Informations techniques / Technical Matters

SUBJECT: CARBURETOR TO MANIFOLD INSTALLATION.

RE: ZEPHYR 340 B.S.E., BETWEEN SERIAL #2C3S9971 & 2C3S10847.

Fig. 1

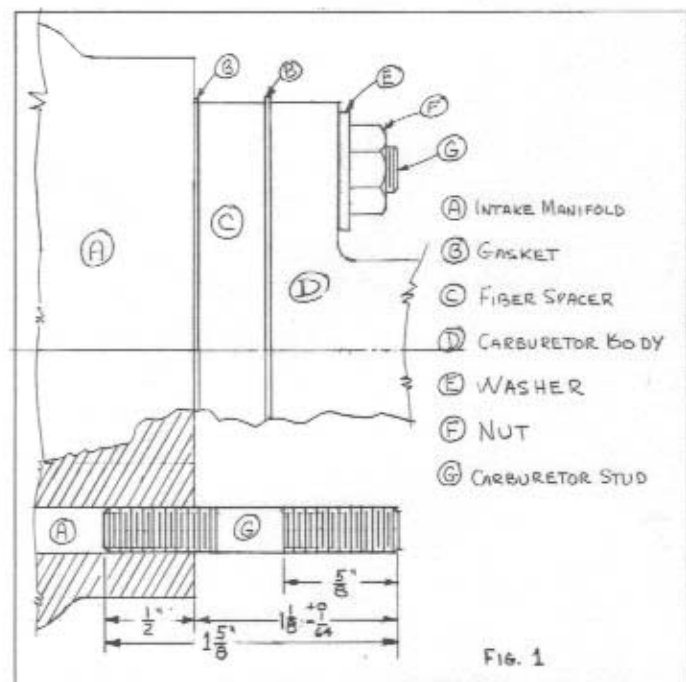
Carburetor studs (fig. 1, ref. G) threaded into the manifold beyond the given tolerances, leaving insufficient thread to adequately secure the carburetor nut on (ref. F).

The nut could loosen through vibration allowing air to be drawn into the engine and creating a lean fuel air mixture.

Extreme cases could provoke a piston seizure.

Remove the carburetor (ref. D), insulator block (ref. C) and gasket (ref. B); screw out the studs (ref. G) to obtain 1 1/8" of stud exceeding the machine face of the manifold (ref. A).

Reinstall the gaskets, insulator block, carburetor, washers and nuts; tighten adequately.

The ideal installation will show 1 or 2 stud thread exceeding the surface of the nut.

We recommend the use of "Loctite Thread, Locking Sealant" #TL-242 to secure the stud into the manifold.
